SAN ONOFRE NUCLEAR GENERATING STATION

Subject: Docket No. 50-362  
Radiation Monitor Recording System  
San Onofre Nuclear Generating Station, Unit 3

### Radiation Monitoring Historical Data Records Availability for the Unusual Event on September 29-30, 1983, at the San Onofre Nuclear Generating Station, Unit 3

ATTACHMENT 2  
 SONGS 203 PLANT VENT STACK/PURGE STACK  
 WIDE RANGE GAS MONITOR HISTORY FILES  
 SEPT 29, 1983 - 10 MINUTE AVERAGES

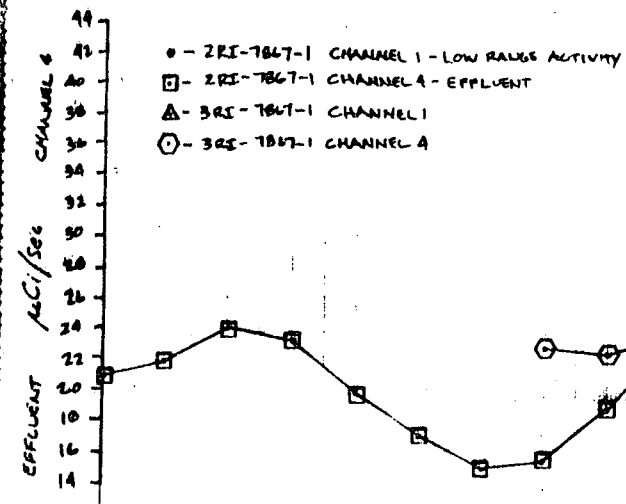
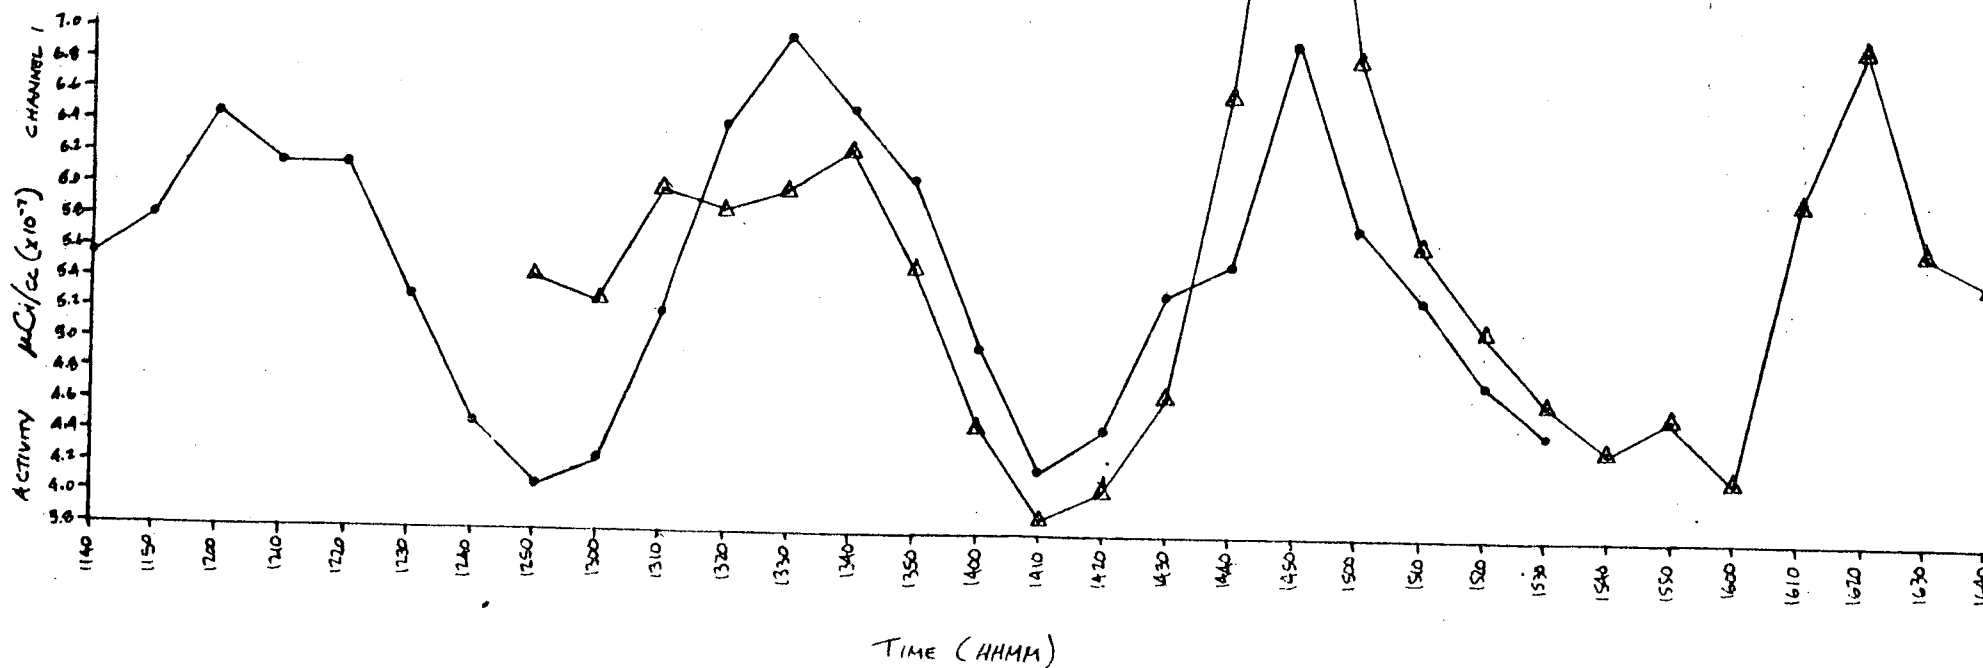
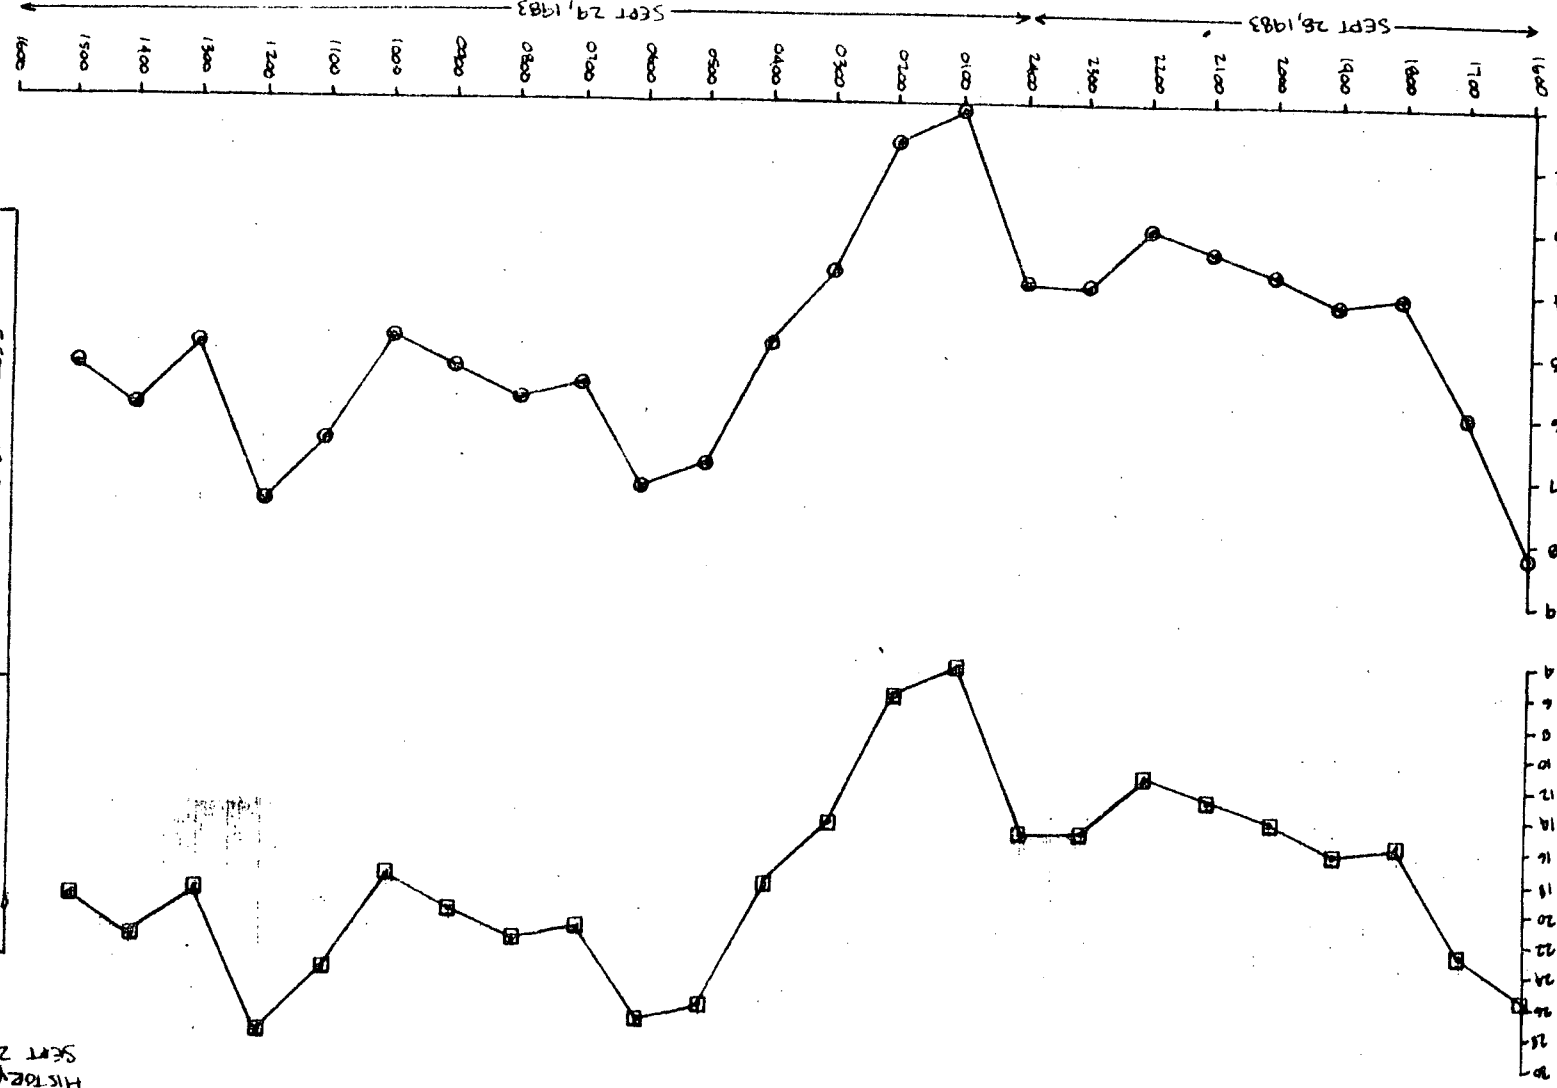
The Unit 2 plant vent stack wide range gas monitor 2-RE-7865-1 low range activity channel and the Unit 3 plant vent stack wide range gas monitor 3-RE-7865-1 low range activity channel did not correlate well; at one time, a factor of 4 difference between the two channels was observed.

The microprocessor-based wide range gas monitors maintain their own history files for each channel (low, mid and high range activity and effluent). The time spans covered for the two monitors overlapped between 1250 on September 29 and 1530 on September 29. A graphical representation of the data for the low range channels indicates that they do indeed correlate well. This data is presented in Attachments 1 and 2. The greatest discrepancy between the two channels, for the overlapping time period, occurred at 1450 on September 29. 2-RE-7865-1 recorded an activity of  $6.97 \text{ E-7}$  microcuries/cc, versus  $9.81 \text{ E-7}$  microcuries/cc for 3-RE-7865-1. The ratio of these two activities is 1.4.

During the event, it is believed that differences noted in the instantaneous meter readings of these monitors was due to "noise" or "spikes" in the data. This is supported by the time average recordings, discussed above, which correlate well. It should be noted that the manufacturer, GA Technologies, has issued Field Change Order FCO-040 to install noise suppression networks on the wide range gas monitors. Installation of FCO-040 will reduce noise emission from check-source and flow control valve relay actuation. DCP's 1074N and 3-1074N have been issued to install these networks. Installation is scheduled in concurrence with the 18-month calibrations on these monitors.
